Pagham church response

Response from Conservation Officer to this RM application

Views of church

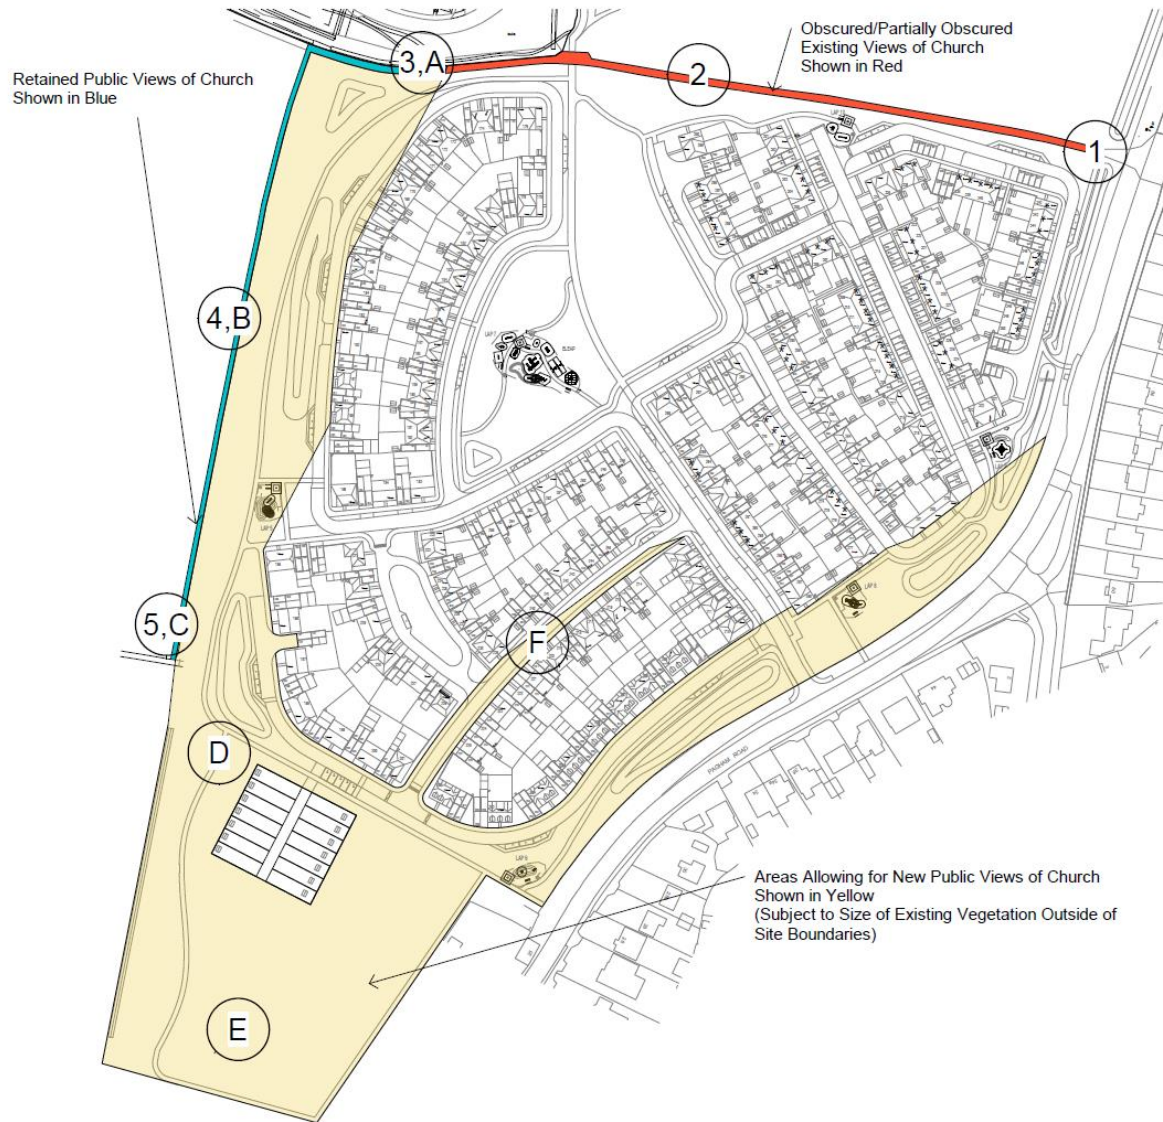
The northern boundary of the churchyard is approximately 330m to the south/south-west of the nearest part of the boundary for the development site, and the church itself is set back further from the lane. It will not impact on the close setting of the church (including the views along Church Lane). There are no views to the proposed development from the church because of the new properties and their grounds on the opposite side of Church Lane, as well as The Old Cottage.

There will also be a slight reduction in the full extent of the longer distance views of the church tower from Summer Lane to the development. Whilst such views of the church is approximately 1km away and visible only in the far distance, the proposed development would impact on the ability to view the tower as a landmark in the wider setting.

The development will lead to the alteration or loss of some of the views of the church, which is currently experienced as a local landmark, set within a semi-rural setting from within the site. It will also reduce a small part of the wider rural setting of the listed building. The result being that it will slightly reduce the ability to appreciate its architectural interest and landmark qualities from one part of the church's setting, with a very minor impact to the significance of the building as a result.
